Title: **Agreed CRs of category "B" (New features) to TS 25.224**

Spec	CR	Rev	Phase	Subject	Cat	Version-Current	Version-New	Doc
25.224	004	1	R99	STTD capability for P-CCPCH, TDD component	B	3.0.0	3.1.0	R1-99k84

25.224 **CR** **004r1** Current Version: 3.0.0

Subject: STTD capability for P-CCPCH, TDD component.

Figure 6: Block Diagram of the transmitter (STTD)

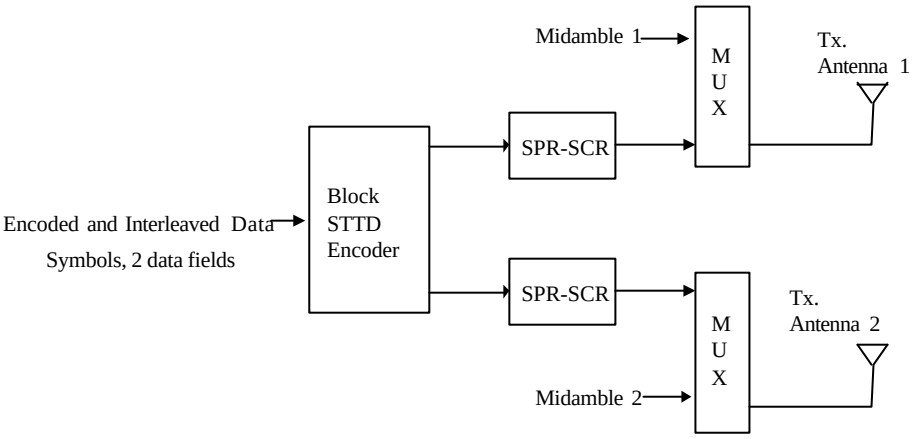
A block diagram of the Block STTD transmitter is shown in Figure 6. Before Block STTD encoding, channel coding, rate matching, interleaving and bit-to-symbol mapping are performed as in the non-diversity mode.

Block STTD encoding is separately performed for each of the two data fields present in a burst (each data field contains N data symbols). For each data field at the encoder input, 2 data fields are generated at its output, corresponding to each of the diversity antennas. The Block STTD encoding operation is illustrated in Figure 7, where the superscript * stands for complex conjugate. If N is an odd number, the first symbol of the block shall not be STTD encoded and the same symbol will be transmitted with equal power from both antennas.
